**Subject: Response to RAI Questions: Application for License Amendment to
Change the Applied Administrative Margin for Finished Fuel Assemblies
at Two Workstations**

Response to NRC RAI Questions

TAC No L31886

Framatome ANP Responses to RAI dated May 5, 2005

Figure 1 Pin layout for the most reactive assembly type – 16 guide tube (GT) and 1 instrument tube (IT) locations.

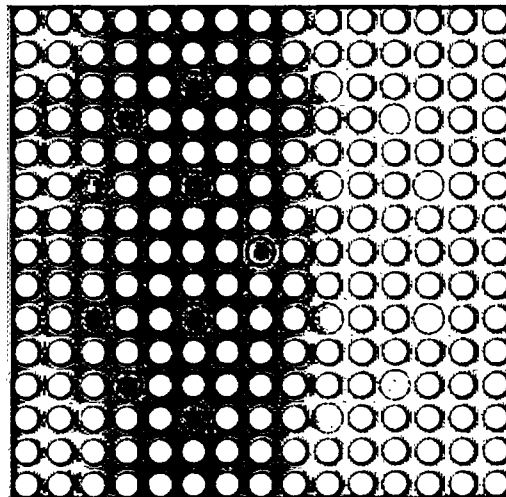
3. In criticality safety analyses for finished fuel assemblies, the assemblies are not modeled with any nominal parameters. Specifically, they are modeled with the maximum pellet outer diameter, the maximum clad inner diameter, and the minimum clad outer diameter. This maximizes the amount of water in an assembly lattice, while also maximizing the amount of fuel. The pellet density is modeled as 97.5% of the theoretical density, and the U-235 enrichment is modeled as 5.1 wt%. The latter adds the largest amount of conservatism to the calculated k_{eff} , as actual enrichment values for specific contracts (assembly designs for power plants) are generally much less than 5.1 wt% (~ 4.5 wt%). Actual enrichment values would not exceed 5.0 wt%.

Table 2 shows worst-case nominal dimensional values (over the existing contracts), manufacturing tolerances, bounding values, and the values that would actually be used in the model (far right column) for the most reactive assembly type produced at Mount Athos Road (MAR). In addition, the pin layout for this assembly type is shown in Figure 1. Note that for this particular assembly type, the enrichment does not currently exceed 4.30 wt%.

The worst case nominal parameters for any given assembly design type produced at MAR were determined by comparing the nominal values for all existing or anticipated fuel contracts that use that given design type, and maximizing the pellet diameter while minimizing the clad thickness and guide tube/instrument tube thickness, and maximizing the amount of water in the assembly lattice. In general, this corresponds to assuming the maximum nominal pellet outer diameter (OD), maximum nominal clad inner diameter (ID), minimum nominal clad OD, maximum nominal guide tube/instrument tube ID, and minimum nominal guide tube/instrument tube OD. The worst case manufacturing tolerances for a given parameter are standard for a given

assembly design type. This study to determine bounding assembly dimensions was performed by a senior criticality safety analyst, and is documented in the "MAR Pit Criticality Safety Analysis", FANP document number 32-5052962-01 (rev. 1 archived internally 3/29/05).

Although the sensitivity of the calculated k_{eff} has not been examined for each of the manufacturing tolerances, the cumulative effect of using conservative modeling parameters has been found to be ~3-4 % Δk for the most reactive assembly type. This reactivity margin is primarily due to the conservative modeling of U-235 enrichment. Changes to other parameters alone, such as the pellet OD, produce statistically insignificant changes in system reactivity.

Revised Figure 6-3

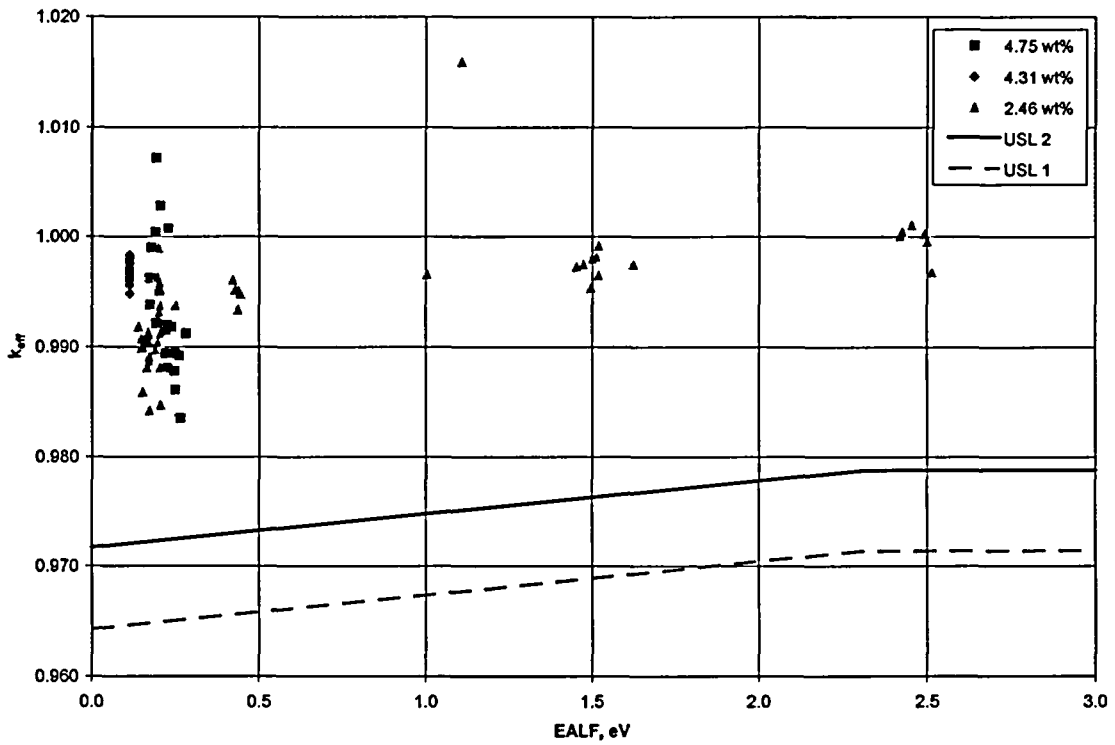
- The discrete enrichments were specifically identified in revised Figures 6-3 and 6-4. In the revised Figure 6-3, considering only the 4.75 and 4.31 wt% enrichment benchmark experiments still provides adequate coverage for the parameter EALF [eV] for the design application involving a single fuel assembly which ranges from 0.19 to 0.25 eV. The validated AOA for EALF [eV] considering only the higher enrichment data ranges from 0.11 to 0.28 which provide sufficient coverage for the application. Excluding the lower enrichment data also reduces the bias from 0.0055 to 0.0052. Including the lower enrichment data leads to conservative results. Therefore, the proposed USL-1 curve for the AOA for EALF [eV] as indicated in Figure 6-3 is appropriate and conservative. Also, using USLSTATS to trend only the higher enrichment data produces a USL-1 result that is consistent with the result using all data. A minimum USL-1 value of 0.965 is indicated in Figure 6-3 of the validation report while the revised calculation (attached below) indicates a USL-1 value of 0.9648 for an EALF value of 0.21 eV.

Therefore, trends in the bias have been adequately evaluated for all discrete subsets of benchmark experiments analyzed in the validation report and the results do not invalidate the USL-1 value proposed for the single fuel assembly application.

Revised Figure 6-4

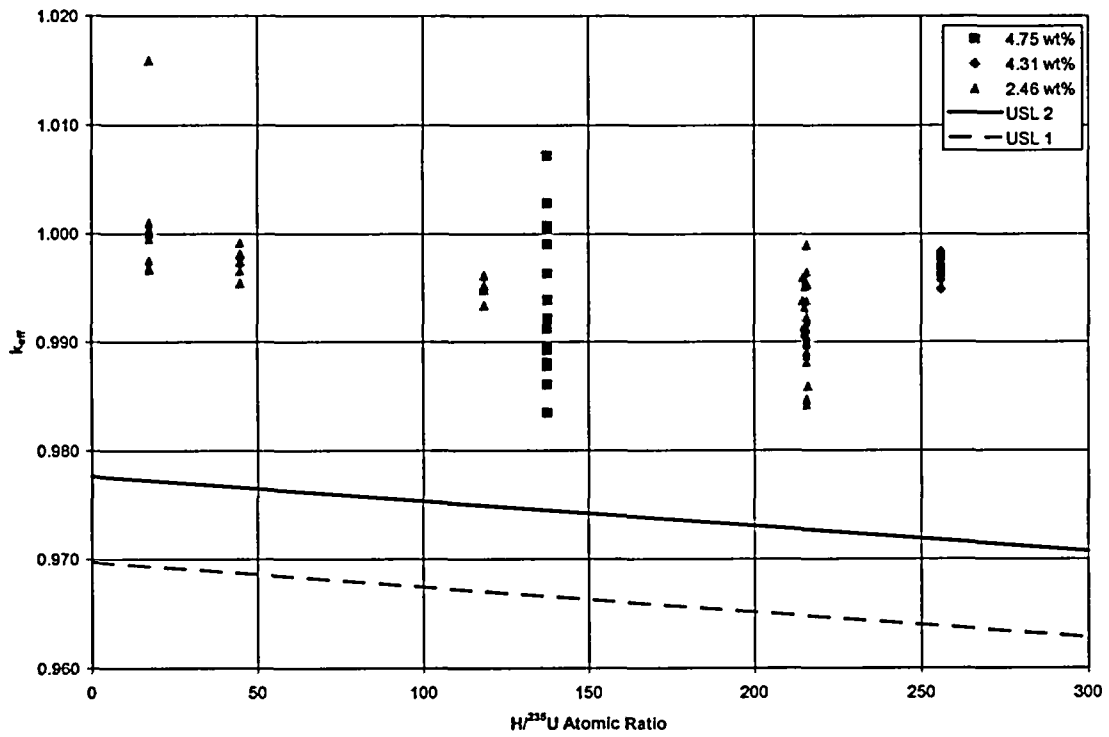
In the revised Figure 6-4, considering only the 4.75 and 4.31 wt% enrichment benchmark experiments still provides adequate coverage for the parameter $H/^{235}U$ atomic ratio for the design application involving a single fuel assembly

which ranges from 156 to 178. The validated AOA for the $H/^{235}U$ atomic ratio considering only the higher enrichment data ranges from 137 to 255 which provide sufficient coverage for the application. Excluding the lower enrichment data also reduces the bias from 0.0055 to 0.0052. Therefore, including the lower enrichment data leads to conservative results. Therefore, the proposed USL-1 curve for the $H/^{235}U$ atomic ratio as indicated in Figure 6-4 is appropriate and conservative. Also, using USLSTATS to trend only the data bounding the single assembly application (156 – 178) produces a USL-1 result that is consistent with the result using all data. A minimum USL-1 value of 0.967 is indicated in Figure 6-4 of the validation report while the revised calculation (attached below) indicates a USL-1 value of 0.9643 for an $H/^{235}U$ ratio of 171.
